APPENDIX 4

Appraisal of Design Audit for the New Barnet Victoria Quarter for the Save New Barnet Group

September 2021

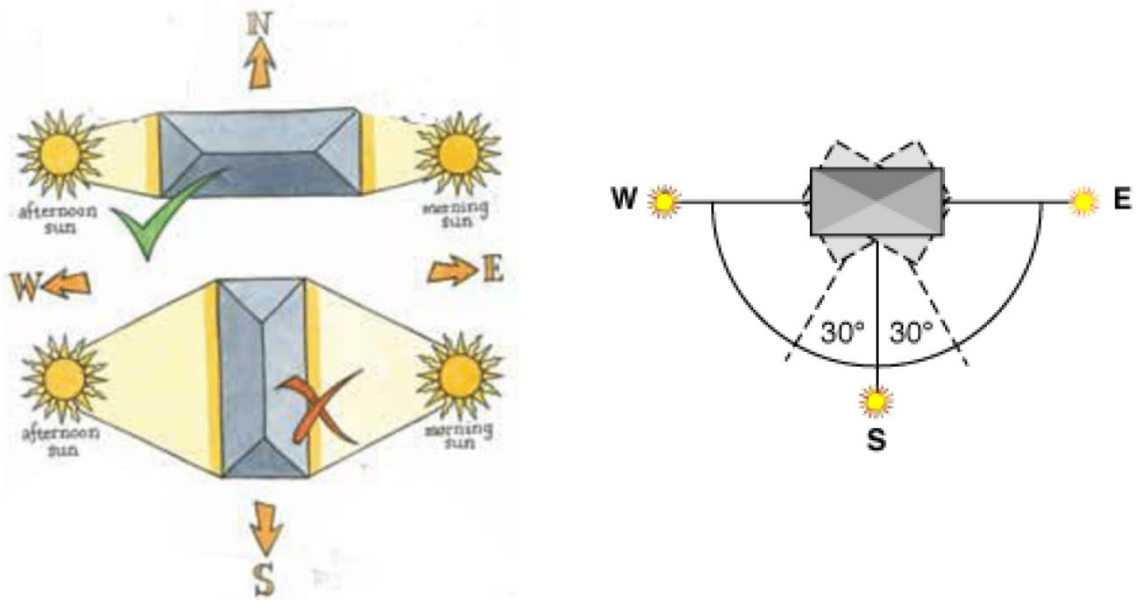
- 4.9. Item 4.14: “The reduced footprint subsequently reduces the long horizontal building form of the refused scheme and achieves a building footprint pattern which provides additional benefits in terms of orientation, improved separation, sunlight/daylight benefits and greater visual permeability”. In fact, the proposed orientation is exactly the wrong thing to do in terms of sunlight, overheating and passive energy design. Passivhaus principles recommend that main facades face north and south, as was the extant scheme for 371 units. As a result of this clumsy replanning, the current proposals are blighted by overheating from low level sun through large unshaded west facing windows. (Refer to diagrams on next page.)

Fig 2 (above): Two diagrams readily available on the internet showing the best orientation for passive solar design. The developers proposals have exactly the wrong orientation (as the red cross lower left) and consequently around 50% of the apartments require active cooling as a result of overheating. By contrast, apartments in the extant scheme of 371 units have a favourable orientation (top left with the green tick), making them inherently more sustainable
